Y/77/15/PL

PLAN-011325

Proposal: Change of use to convert existing barn to a residential dwelling.
Single storey extension to east & north facing elevations. Patio & car parking.
Site: Hoe Barn Cottage, Hoe Lane, Flansham, PO22 8NS.
Y/77/15/PL

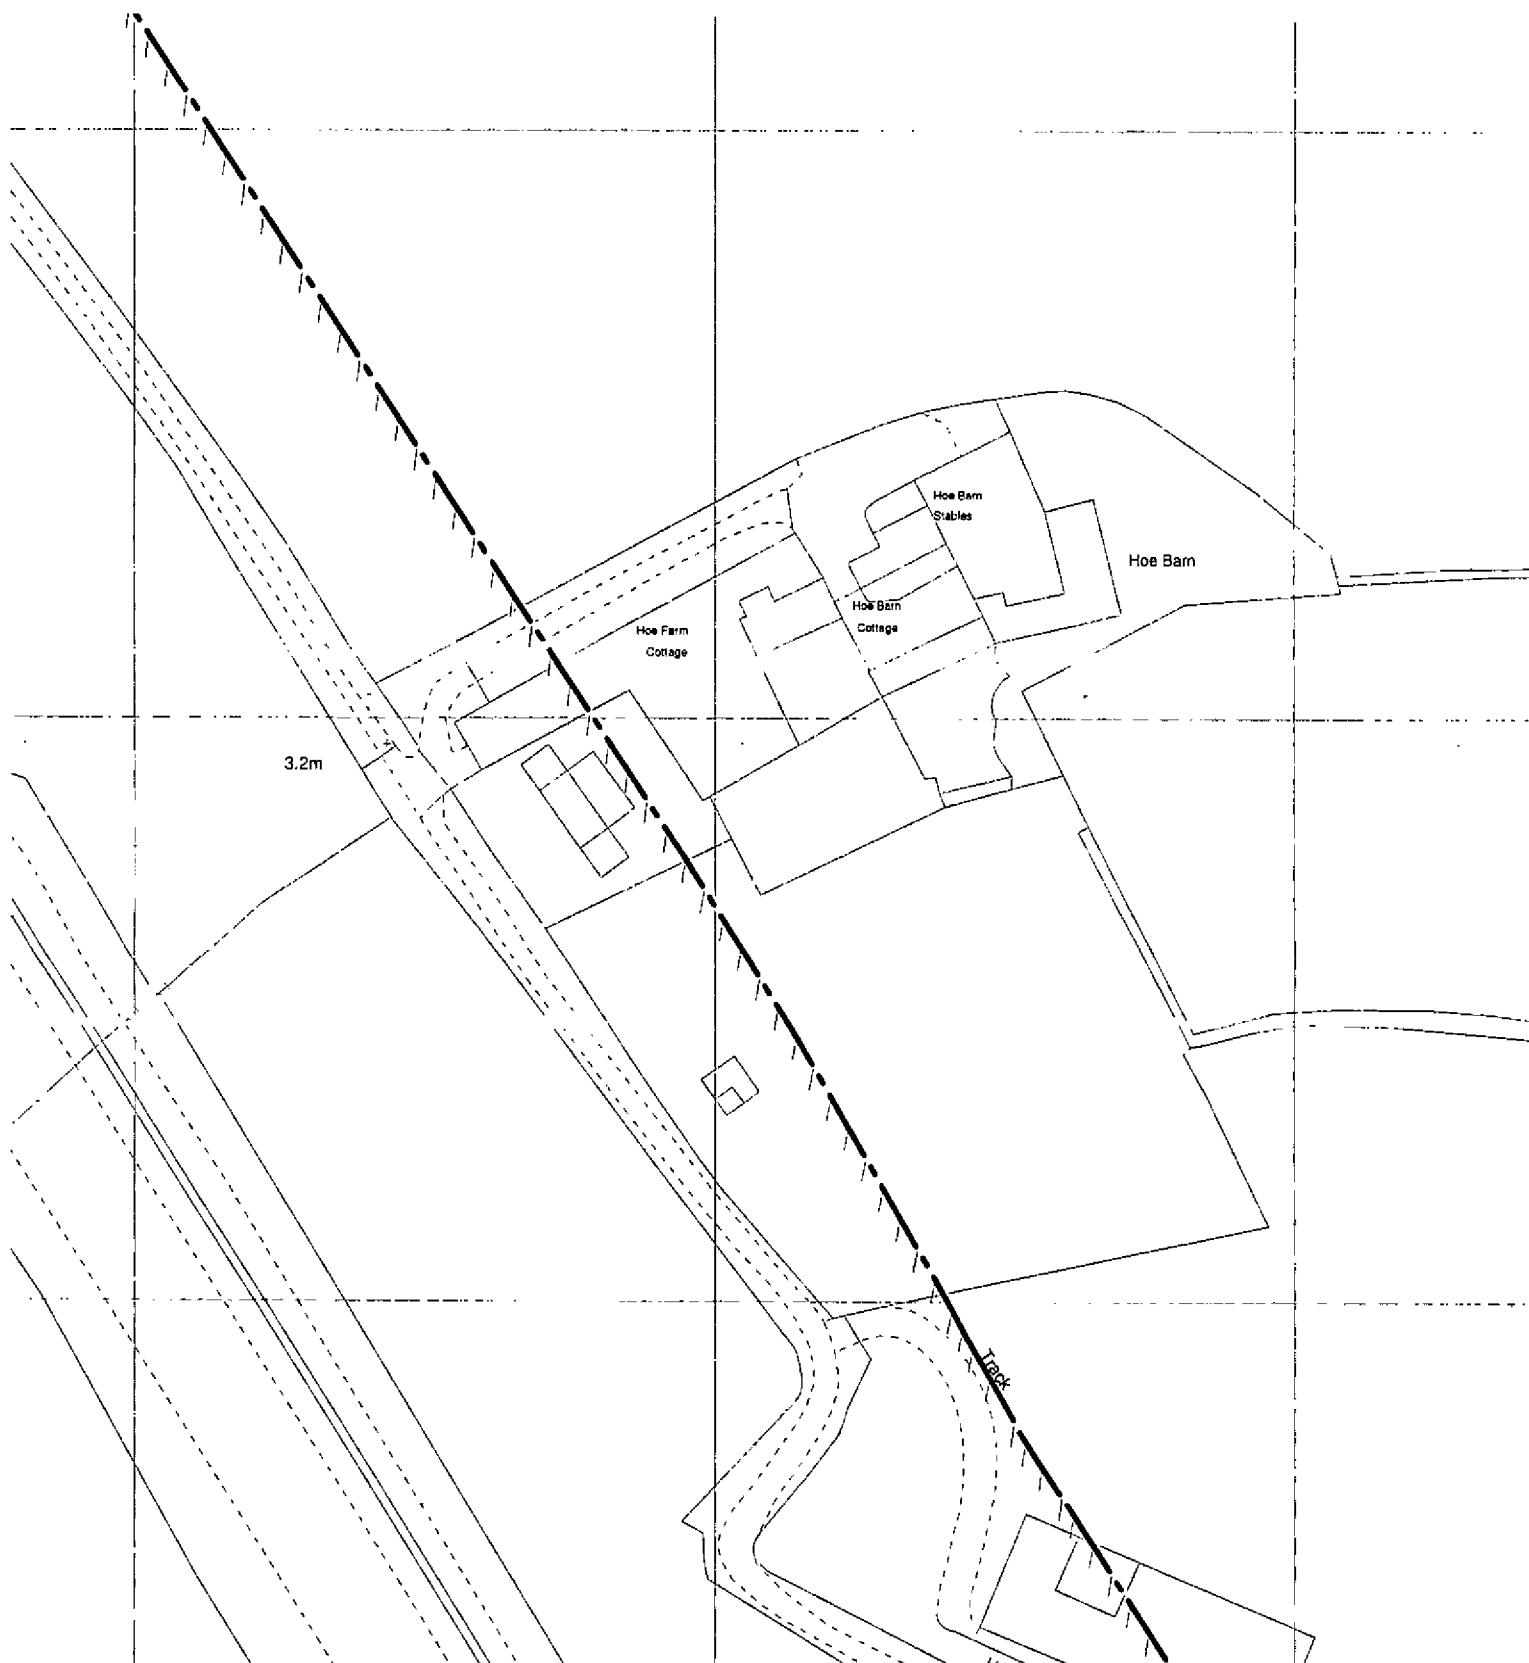
The attached plan shows that the proposed development lies close to an existing public foul rising main. An on site investigation is required to ascertain the location of the foul water rising main before any works commence. Part H of the Building Regulations dictates that the matter is determined by the sewerage undertaker – in this case Southern Water. The applicant is advised to discuss the matter further with Southern Water, Sparrowgrove House, Sparrowgrove, Otterbourne, Hampshire SO21 2SW (Tel: 0330 303 0119) or www.southernwater.co.uk. No new development/foundations are permitted any closer than the existing building line.
